CHANGE ORDER

Project Name: **Haverhill Consentino Middle School** CO No. **06**

Architect's Project No. **21-0818**

JD-15

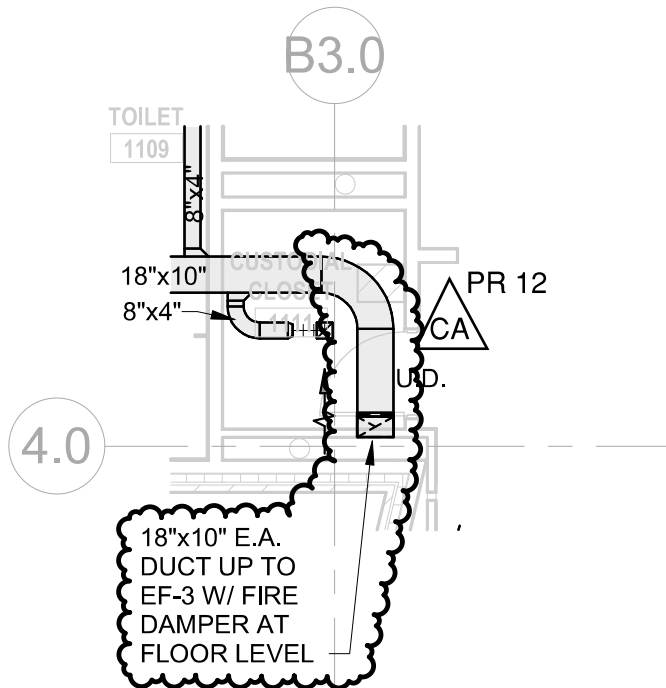
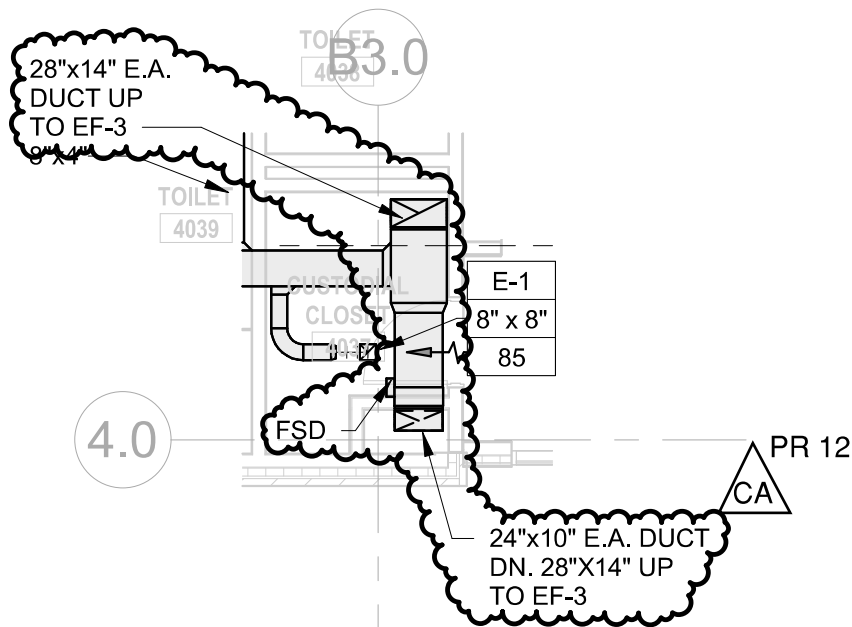
At Sheet M1.11, HVAC – Fire Floor Plan – Area A / B Ductwork and Sheet M1.21, HVAC – Second Floor Plan – Area A / B Ductwork, revise layouts as shown on attached sketch **JD-15**.

RFI #57/PR #12 - REVISIONS TO
EF-3 EXHAUST DUCT

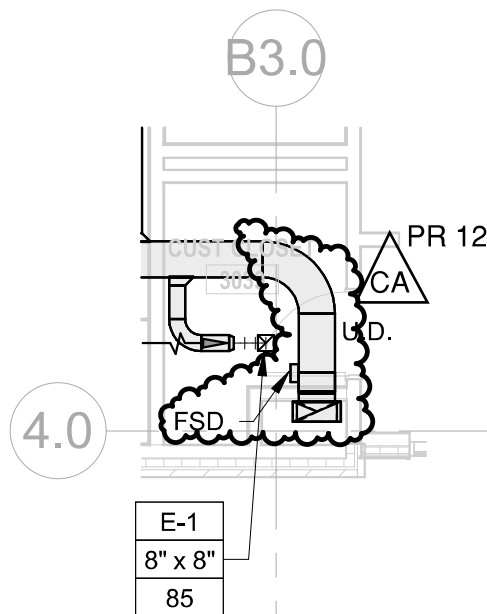
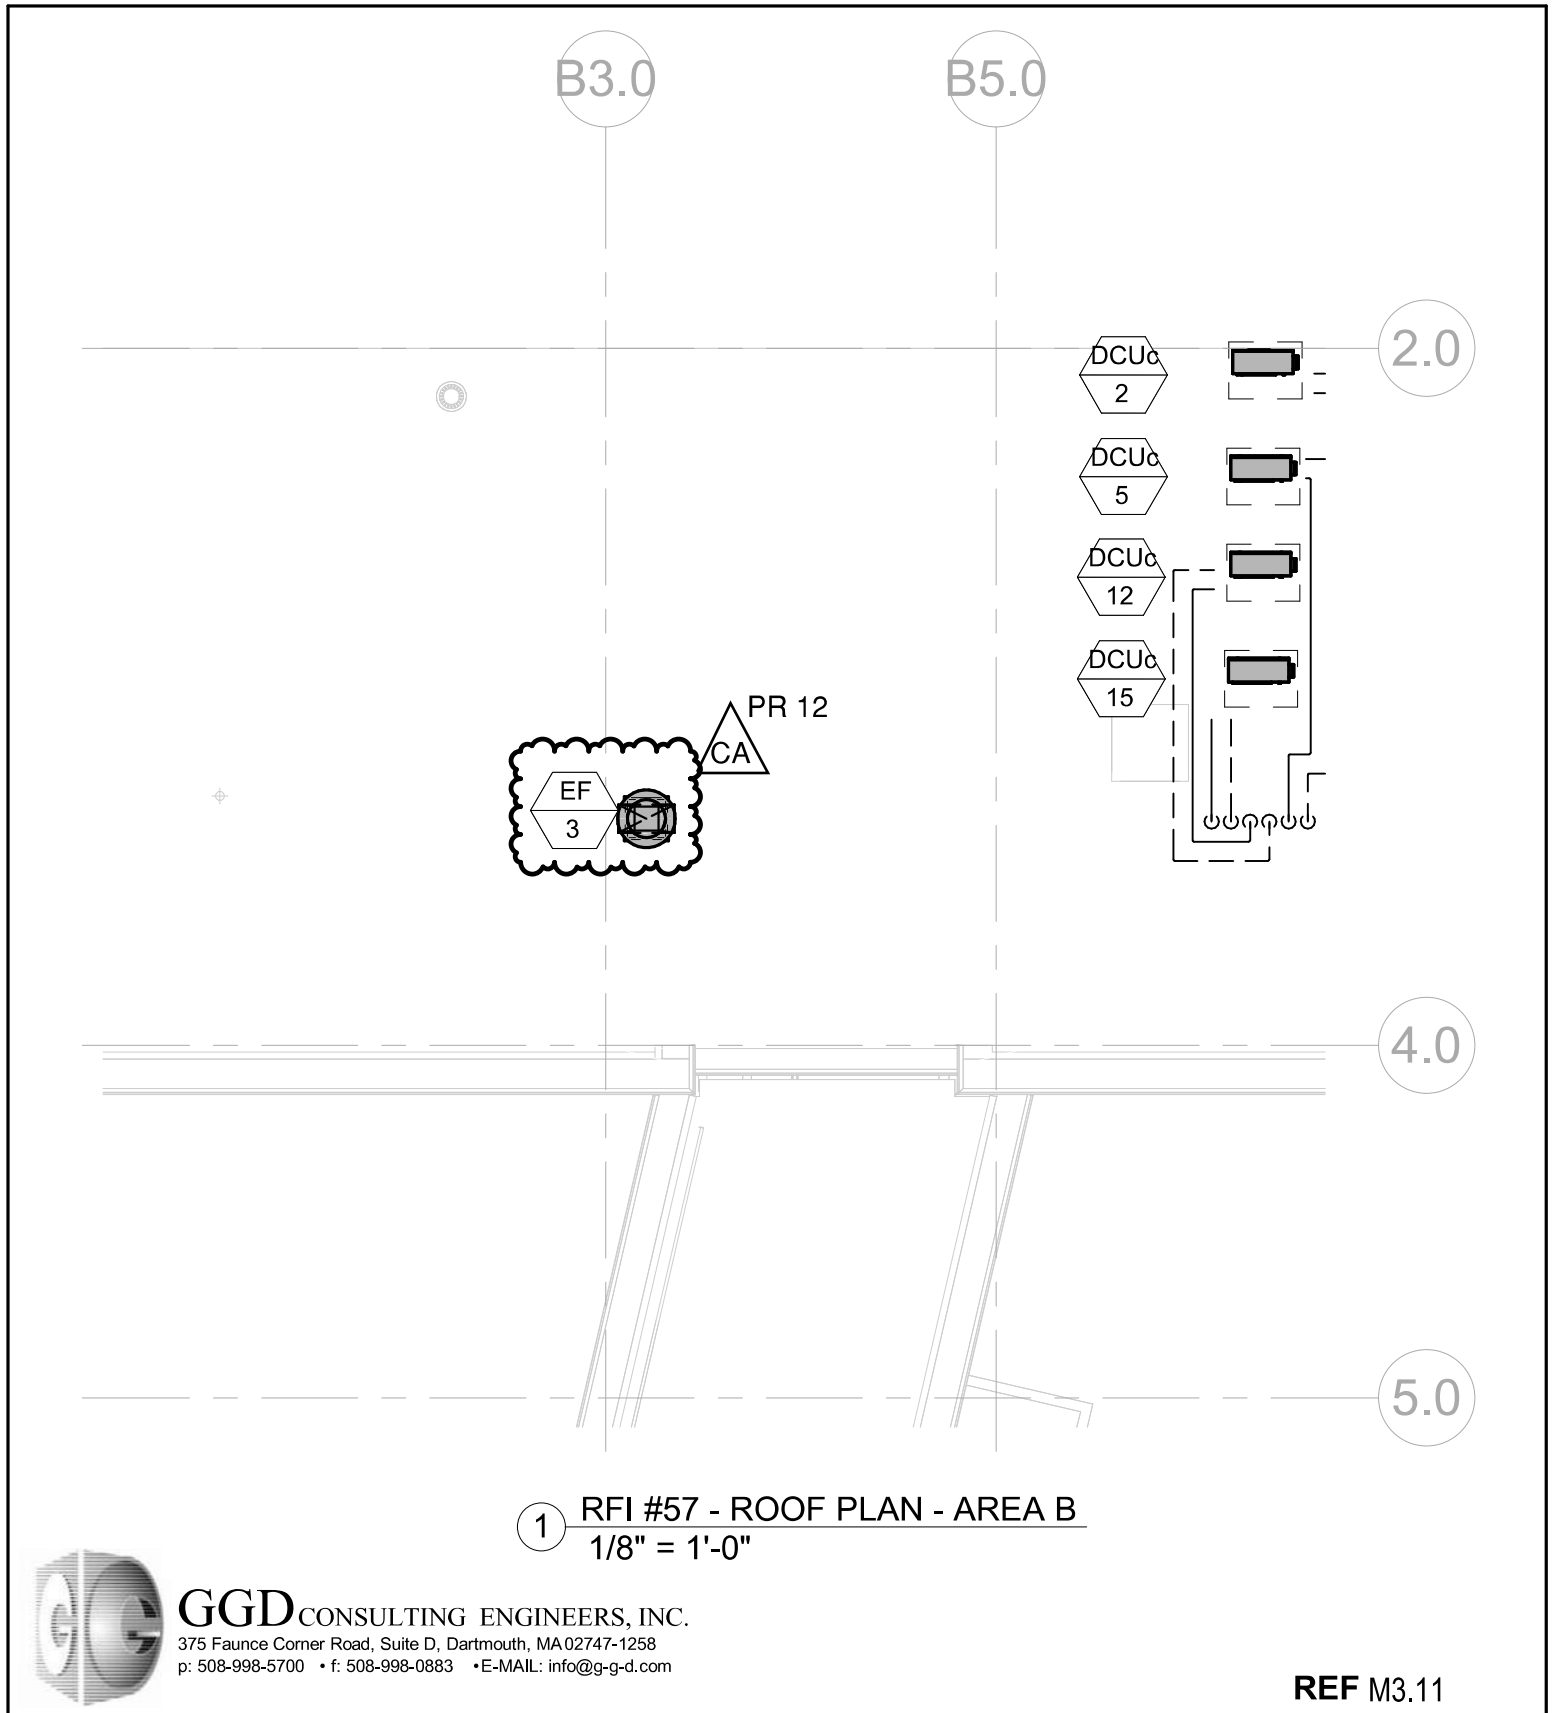
Sketches "JD-15" and "JD-16" attached to PR-012 indicate two different kinds of a life-safety dampers. Tag provided on ductwork indicate "FSD" which would be Fire Smoke Damper. Call-out notes provided on sketches indicate "Fire Damper". Please clarify which type of life-safety dampers are required.

At Sheet M1.31, HVAC – Third Floor Plan – Area A / B Ductwork and Sheet M1.41, HVAC – Fourth Floor Plan – Area A / B Ductwork, revise layouts as shown on attached sketch **JD-16**.

**RFI #57/PR #12 -
REVISIONS TO EF-3
EXHAUST DUCT**

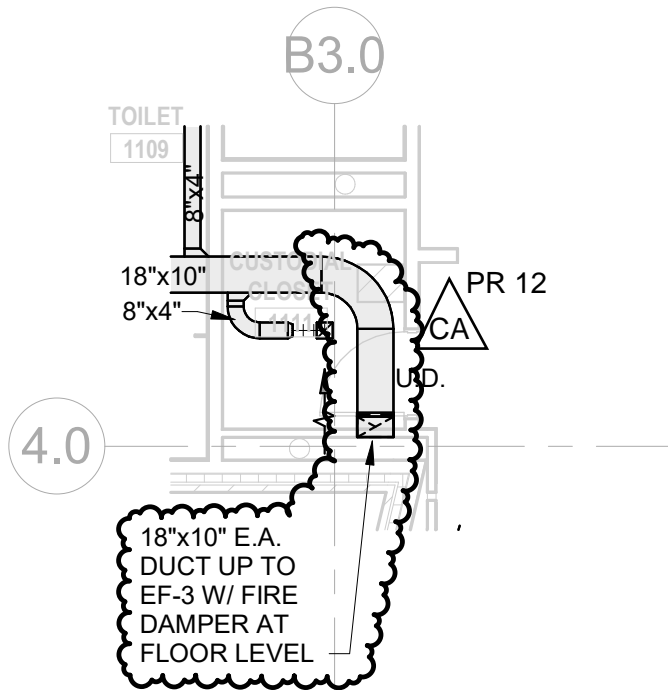
At Sheet M1.11, HVAC – Fire Floor Plan – Area A / B Ductwork and Sheet M1.21, HVAC – Second Floor Plan – Area A / B Ductwork, revise layouts as shown on attached sketch **JD-15**.

REF M3.11

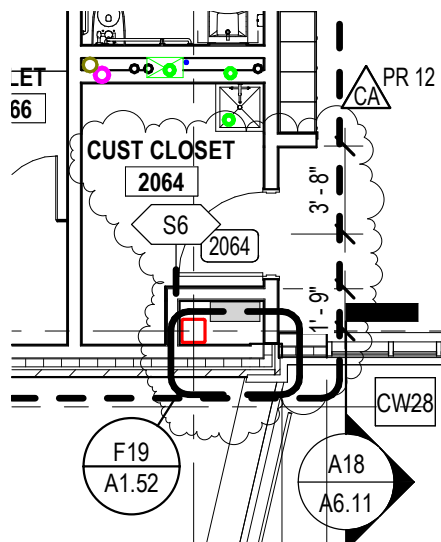
At Sheet M3.11, Roof Plan – Area B, revise EF location as shown on attached sketch **JD-17**.

F19 PLAN DETAIL - X1.11 / X1.23 INSIDE CORNER AT GRID B3.0 / 4.0
 1 1/2" = 1'-0"

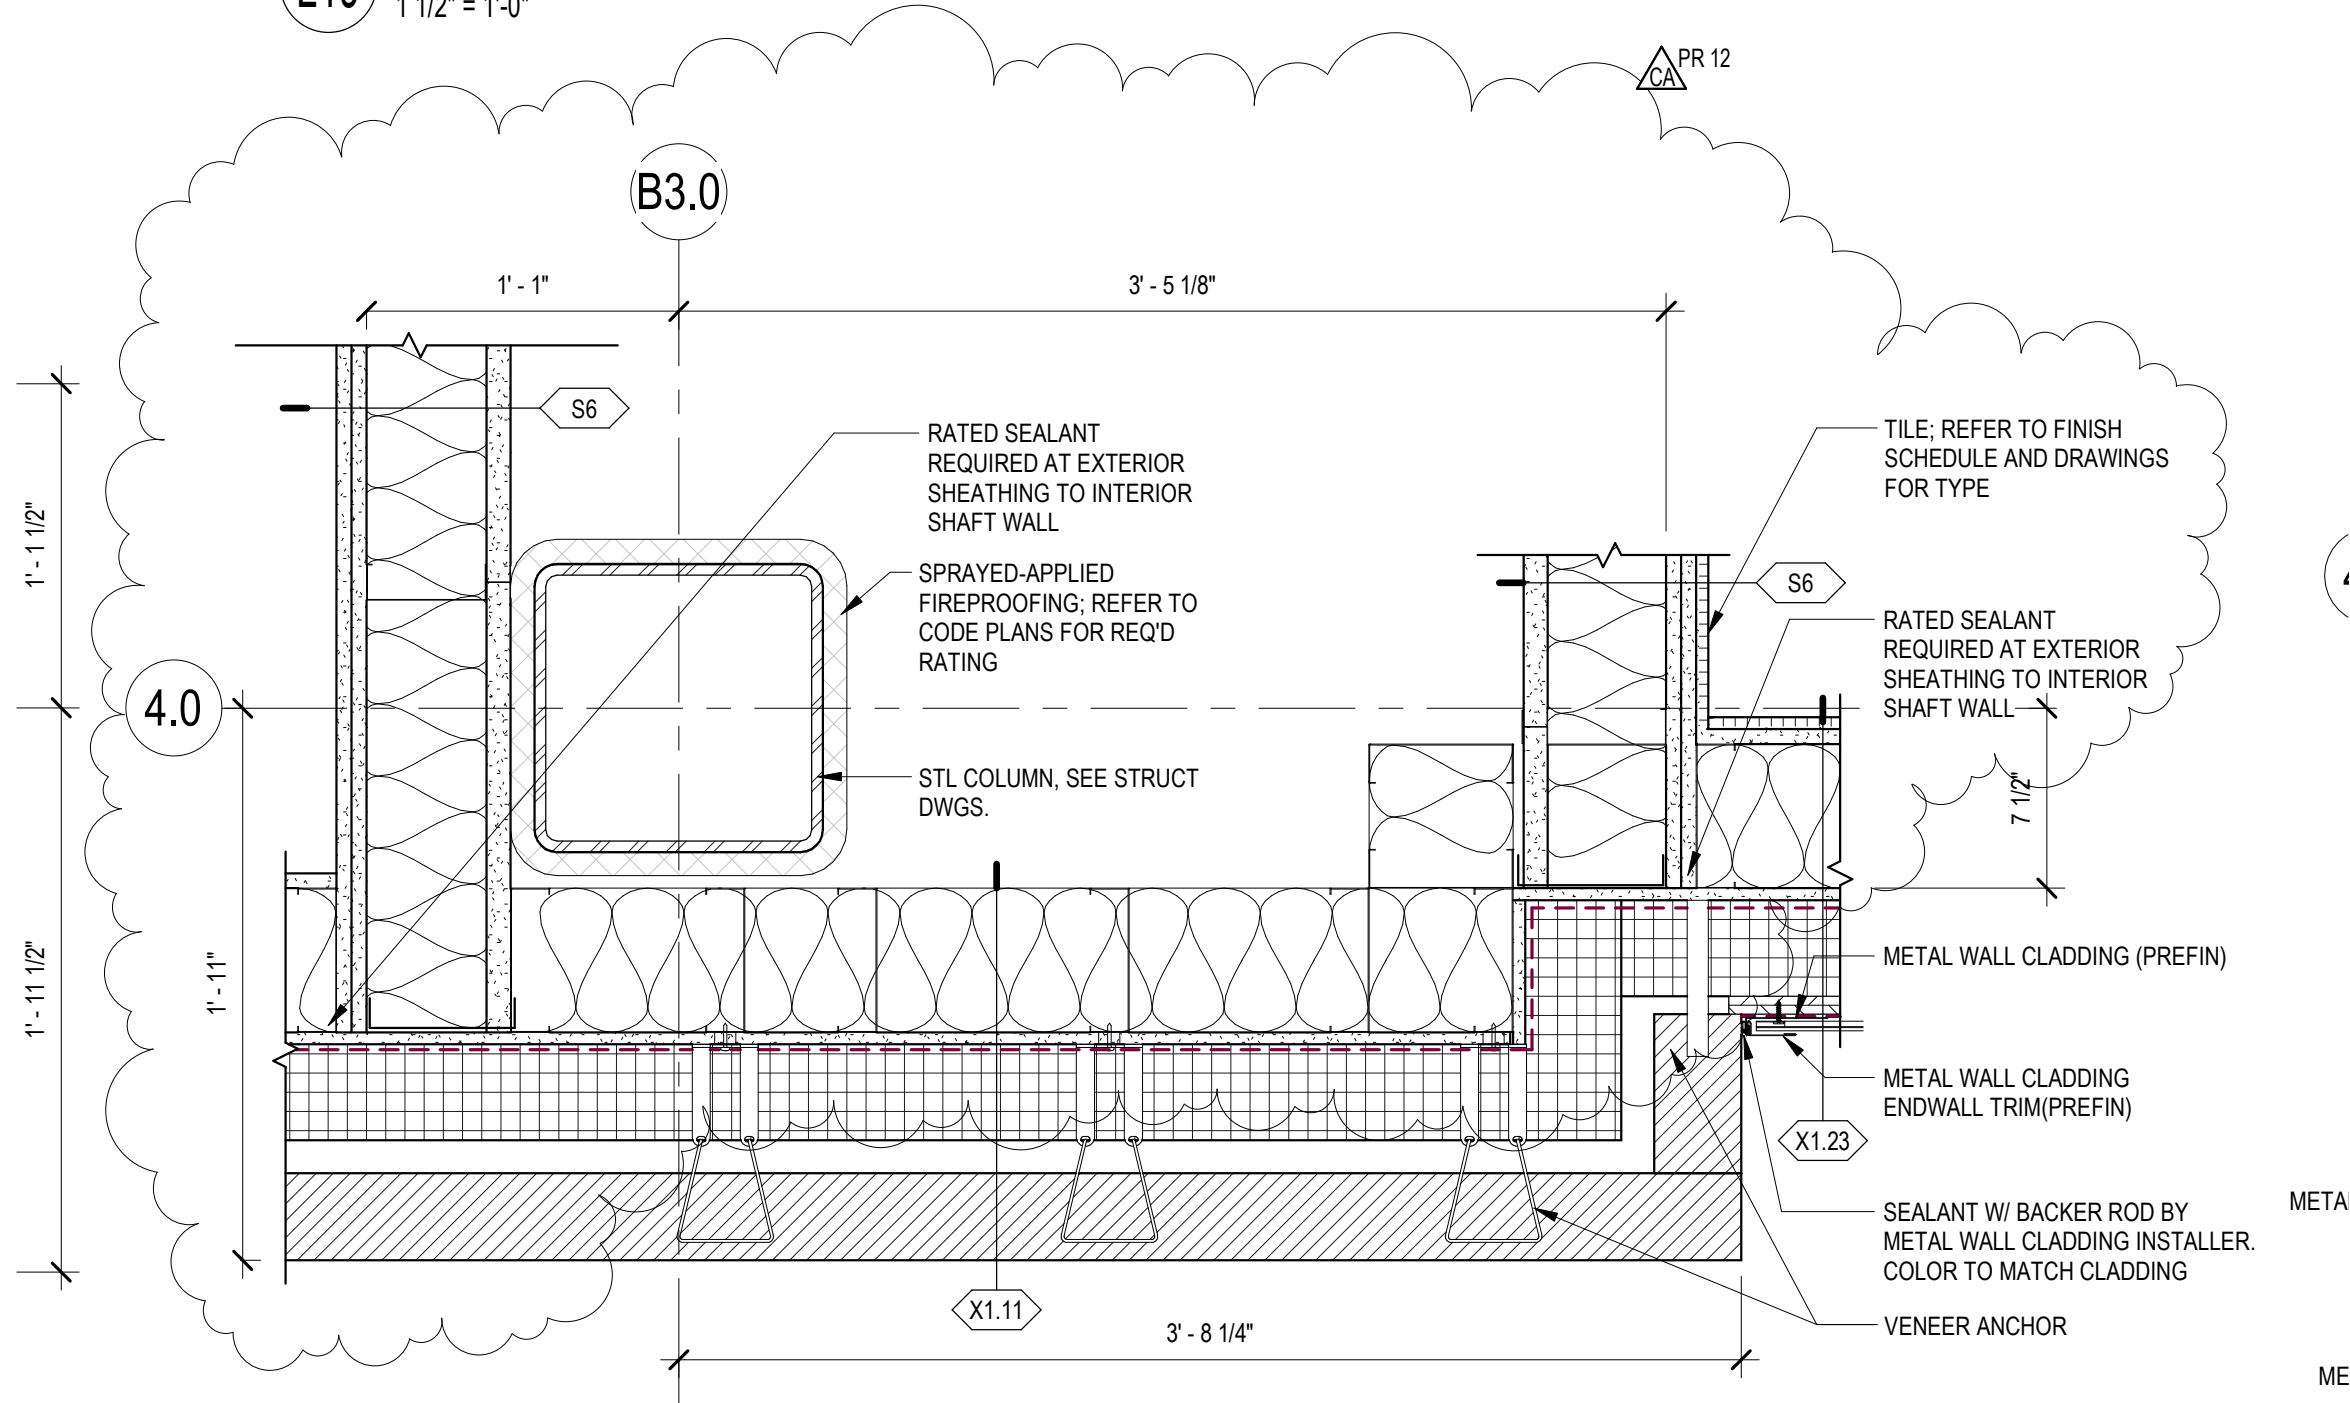
At Sheet A1.52, revise detail F19 as shown on the attached sketch **JD-19**.

JD-70

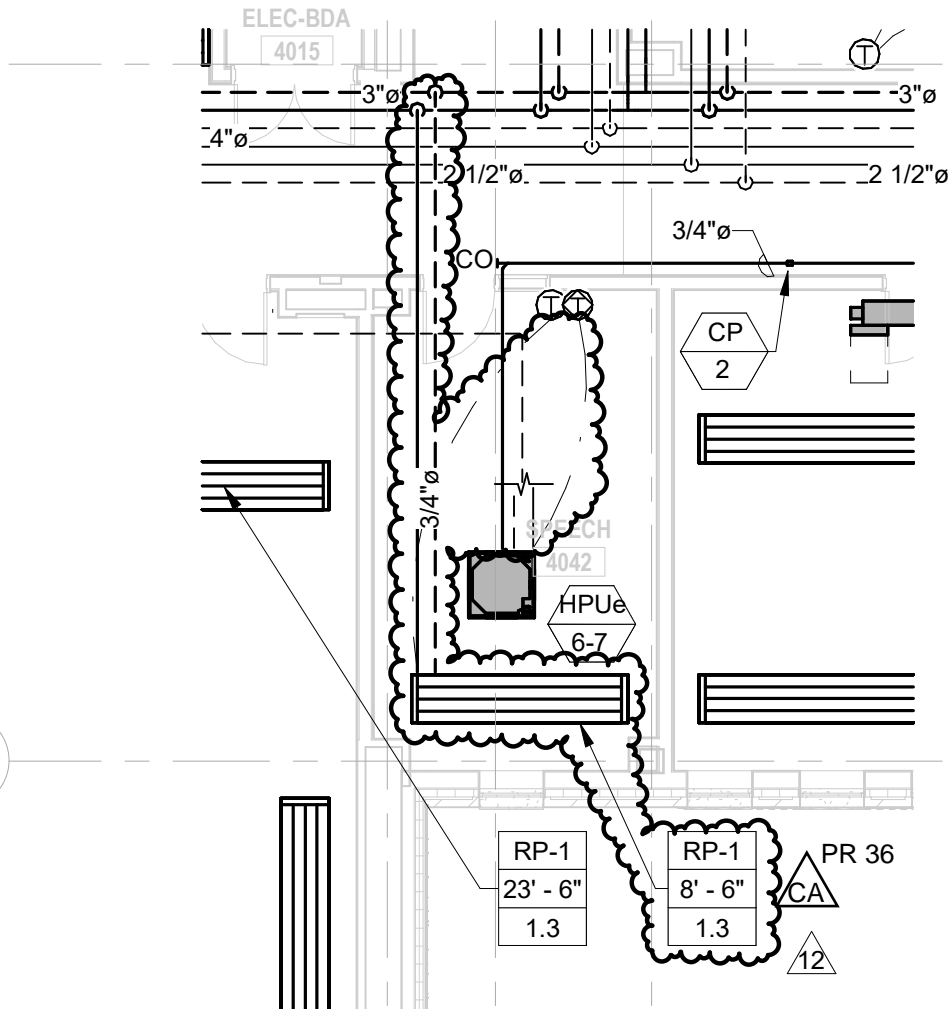
In response to RFI 132, at Sheet M2.41, revise RP-1 at room 4042 as shown on attached sketch **JD-70**.
